M-TIPS

2004 RX-8

Lack of A/C Cooling

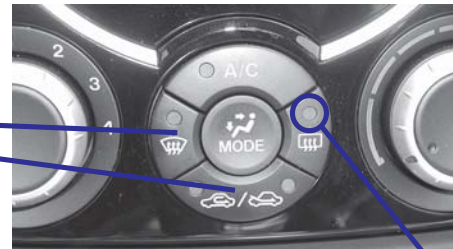
1. Verify customer concern.
2. Turn ignition switch to LOCK position.
3. Press and hold FRONT DEFROSTER and AIR INTAKE CONTROL switches simultaneously. Continue holding switches through Steps 4 & 5 below.

4. Turn ignition switch to ACC position for three (3) seconds, then to ON position for three (3) seconds.
5. Watch REAR DEFROSTER indicator light. Reprogramming is successful if REAR DEFROSTER indicator light flashes three (3) times. If not, repeat Steps 2-5.
